## STUDY on LED replacement light sources introduction into Regulation No. 37

**STUDY on LED  
replacement light sources  
introduction into R37  
Status 2020-07-08**

**Addendum 36 – Regulation No. 37**

**Revision 7 - Amendment 8**

#### Example of the arrangement of the approval mark

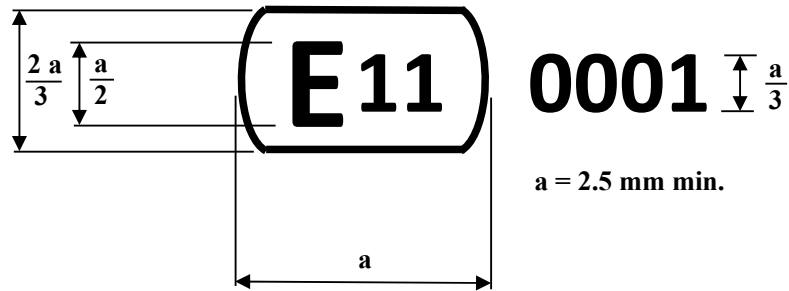
The above approval mark affixed to a ~~filament~~ light source indicates that the light source has been approved in the United Kingdom (E 11) under the approval code 0001.
